RE: Development Application MCUC 2915/2018, 20 Warner St, Pt Douglas. RFI 18007CL

MICRO HOTEL, 20 WARNER STREET – PORT DOUGLAS
DEVELOPMENT APPLICATION MCUC 2915/2018

RESPONSE TO INFORMATION REQUEST (Council Ref. MCUC
2915/2018(DocID881197) dated 22 Nov.2018 FOR 20 WARNER STREET,
PORT DOUGLAS; LANDSCAPE.

**Re: Development Application MCU for Short-term Accommodation (Hotel)
20 Warner Street, Port Douglas**

7a. Please review the Landscape Sheet LS_04. It is proposed;

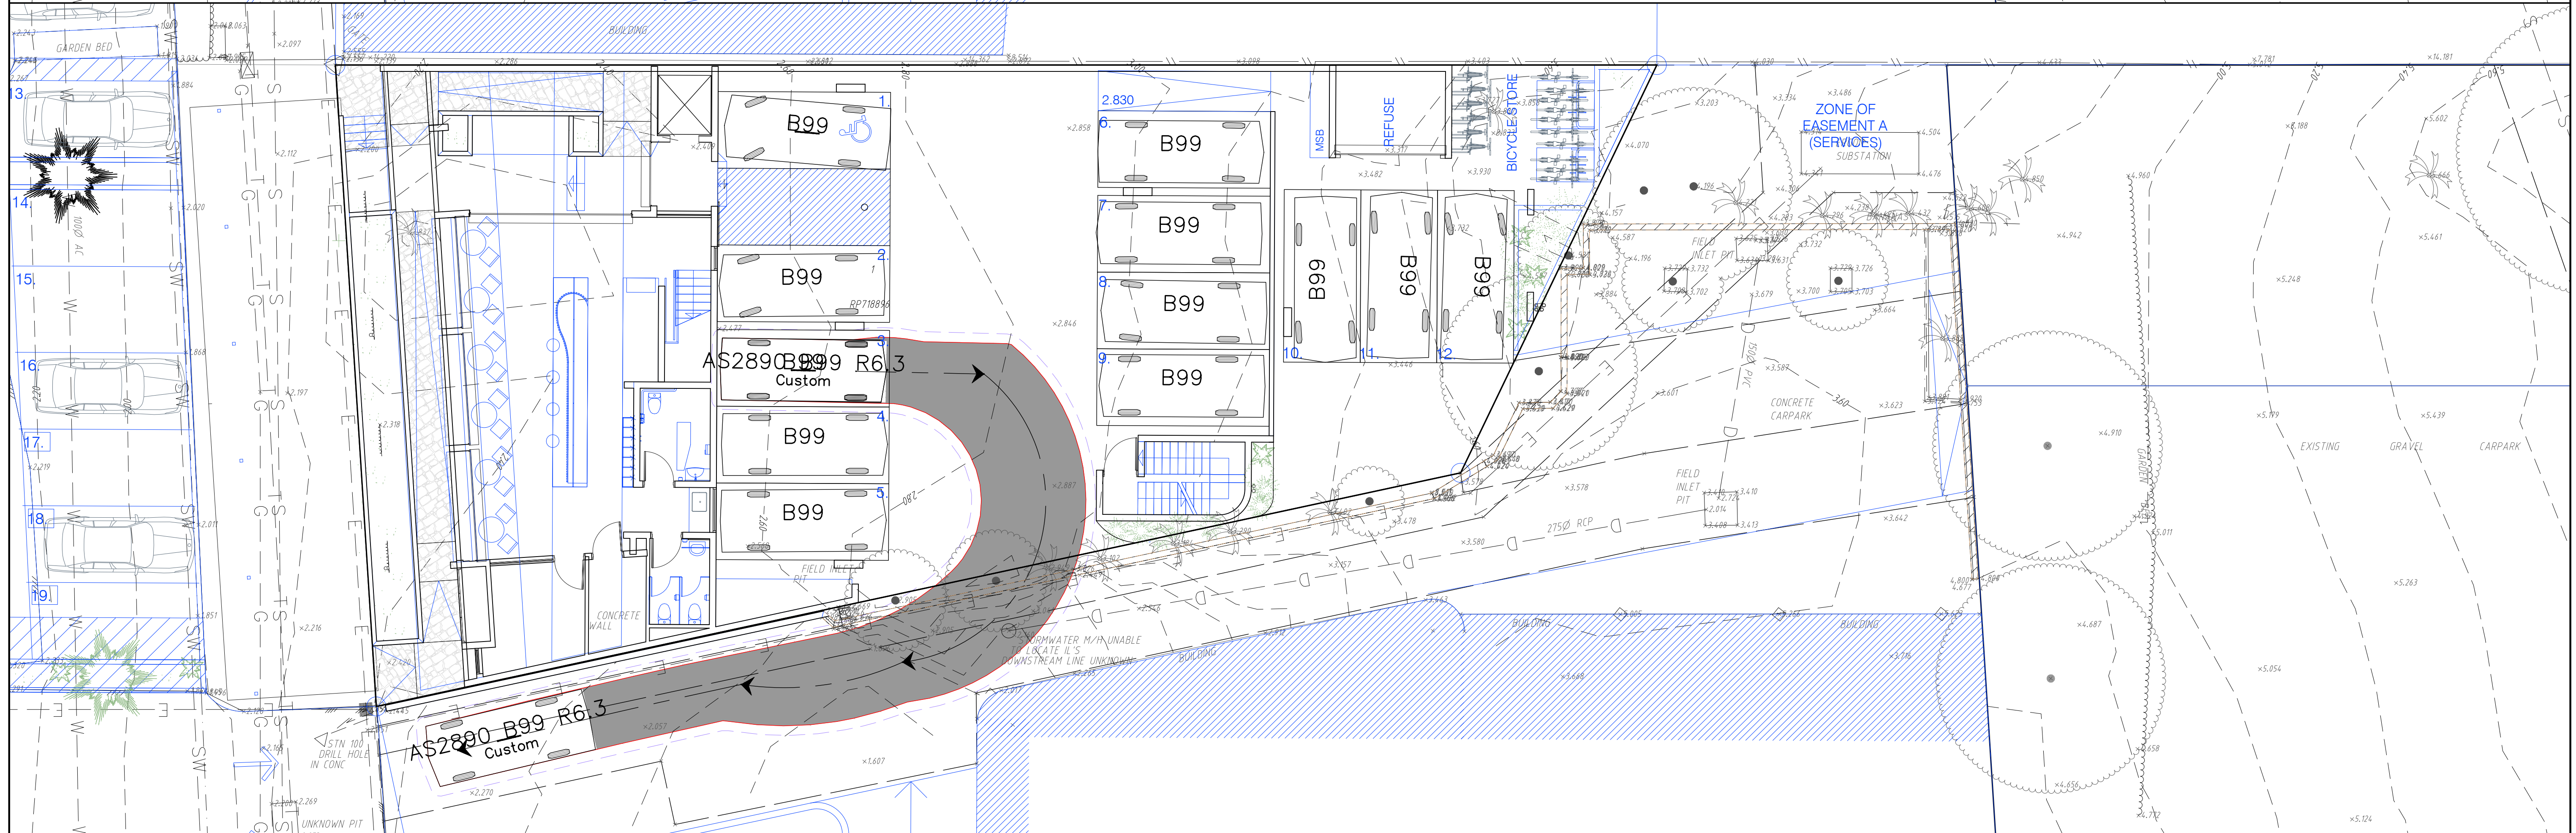
7. Sections a. Please provide sections and drainage details for the landscaped voids and areas of vertical landscaping that commence at the first floor level detailing the depth of deep planting to the soil boxes and the indicative drainage scheme. Indicate all areas of the ground floor where headspace is reduce by the impact of the planter areas above. b. Please provide sections of the unit entry area, in particular the corridor elevation of the units. c. Please provide detail of how the unit's security door will enable through breezes and maintain privacy.	The consultant landscape architect has provided further information on the details of the planter boxes, including sections and drainage details. Refer to Appendix 4 for further detail. The updated architectural drawings include the relevant details in relation to items b and c. Please refer to Appendix 1 attached.

1. that each planter box contains a Primary Storm Water Pit, which is connected to a separate storm water system only connected to planter boxes and NOT to the roof run-off storm water system.

2. Each primary pit is connected directly through the Level 1 slab and attached to a garage wall, running vertically to the garage slab to be directed to approved discharge area. This will eliminate any encroachment of storm water pipes into headspace on the parking level.

3. In the long planter box on the north-western boundary a series of secondary storm water pits would be connected to the primary pit by running the pipes on top of the floor of the planter box.

4. The base of the planter box and sides of the planter box connected to internal walls shall have plastic 50mm Drainage Cell to allow the free movement of moisture to collection points.

5. Agricultural pipe beside the Drainage cell will be connected to 100mm PVC Storm Water pipe, directly below the pits to allow ease of inspection for debris and plant roots. This will also allow for ease of cleaning of the system.
